# **5 VOLT FlashFile™ MEMORY**

## **28F004S5, 28F008S5, 28F016S5 (x8)**

### **SPECIFICATION UPDATE**

Order Number: 297796-007

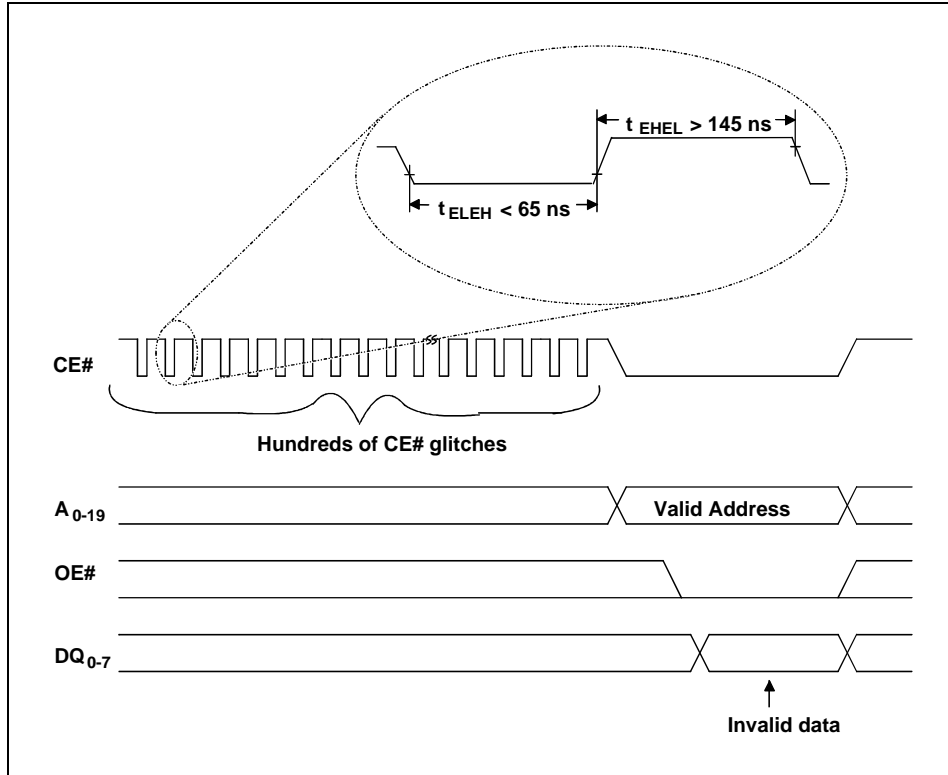
**PROBLEM:** For the 8- and 16-Mbit devices that are effected by this erratum, the block unlocking security feature is currently nonfunctional. Attempts to unlock blocks, using the clear block lock-bits command sequence, may cause subsequent program and/or block erase failures. The failure is seen as a device protection error in the status register.

**IMPLICATION:** Block unlocking feature is disabled. This erratum effects the following command, Clear Block Lock-Bits. Locking blocks using the Set Block Lock-bits command (while RP# is equal to 12 volts) is still supported.

**WORKAROUND:** To prevent accidental software block lock-bit clearing, Intel permanently sets the master lock-bit during the test flow. This disables the ability to lock and unlock blocks via software only with RP# =  $V_{IH}$ . Block locking and unlocking requires 12V on the component's RP# input when the master lock-bit is set. Don't execute the clear block lock-bits command sequence when 12V is applied to RP#. Instead, simply override the block locking mechanism by applying 12V to RP# to enable program/erase operations that target locked blocks.

If data security is of utmost importance, lower  $V_{PP}$  voltage equal to or less than  $V_{PPLK}$  during normal operations. With  $V_{PP}$  equal to or less  $V_{PPLK}$ , the device is protected against all data manipulation operations.
